TECHNICAL SERVICE BULLETIN

Technical Service Bulletin Number- TSB0011

Item, Unit or Assembly Affected- Some Shift-N-Step Units

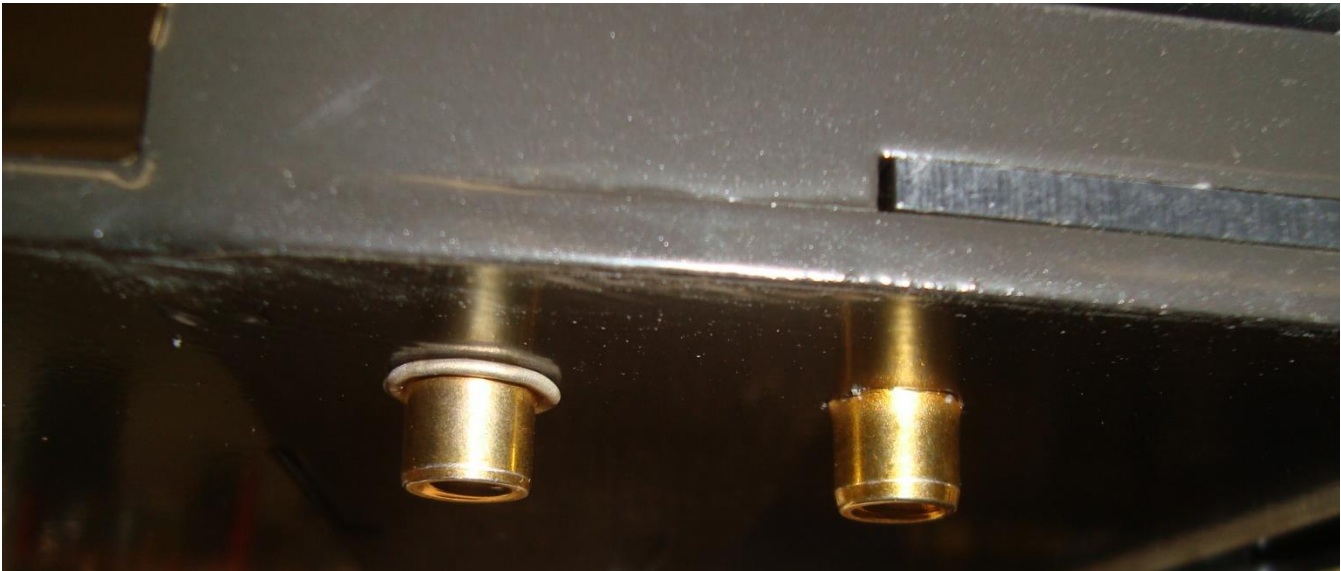
Reason for Bulletin- Possible Installation of incorrect rivet nuts into Shift-N-Step Base. Some Shift-N-Step units were assembled using the incorrect rivet nuts. Before installing any Shift-N-Step unit, carefully inspect the bottom side. There are 38, ¼-20 Flat Head Socket Cap Screws that attach the Top Plate to the Base Assembly (typical as shown below).

The Base Assembly contains 38 corresponding rivet nuts. If the incorrect rivet nut was installed, there is a possibility that the bolt could extract the rivet nut out of the bottom plate, resulting in a failed connection.

Action Required- DO NOT INSTALL ANY SHIFT-N-STEP UNIT UNTIL CHECKED FOR THIS DEFECT. Carefully inspect the bottom side of the Shift-N-Step Base at ALL 38 locations.
